Tay 611-8C EEC Software Upgrade Program

ATA 71, Jeff Tome, 912-965-7303

Figure 1

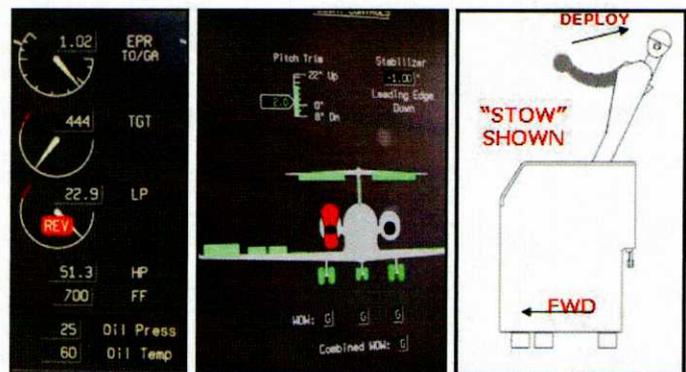
An anomaly of T5.1 has been observed on a few aircraft in which operators may inadvertently induce red indications on the engine instruments and the flight controls synoptic page while operating the thrust reversers. The thrust reversers will continue to operate as commanded but the affected engine will be limited to idle forward thrust when stowed. This happens during ground operations only and typically appears during taxi when the T/R is being used to reduce taxi speed

The red “REV” indication (see figure 1) on the LP RPM Gauge and a flashing “red reverser” (see figure 2) indication on the Flight Controls Synoptic (with no associated CAS message) may occur if the following two conditions in combination are met:

- Repeated deployment of the reversers in succession (deploy - stow - deploy) (see figure 3) with less than ten (10) seconds pause between the end of the “stow” and the start of the “deploy” cycle.
- Delay in the movement of the thrust reverser levers between the “stow” and “deploy” positions.

The EEC believes it has detected a T/R inadvertent deploy due to a subtle difference in timing between the EEC and TRCU. The timing is unique to T5.1 software due to the use of microswitches in the TQA to initiate the deploy signal to the EEC. The condition

Gulfstream and Rolls-Royce are working on a permanent solution, but in the interim the following operational guidance is offered. When using the reversers during taxi to regulate taxi speed or when using the reversers to decelerate after landing, the movement of the reverse levers from forward thrust to the idle reverse detent or higher and back to forward thrust should be a crisp movement of the levers. Do not delay in either direction when moving the thrust reverse levers between stow and deploy positions. Intentionally delay approximately 10 seconds between thrust reverser “stow” command and the next “deploy” command.

Should the red “REV” icon in the LP RPM gauge and flashing “red reverser” indication on the Flight Controls Synoptic occur, the corrective action is to shut down the engine and to restart it. Once running, perform a normal thrust reverser check on the affected engine.
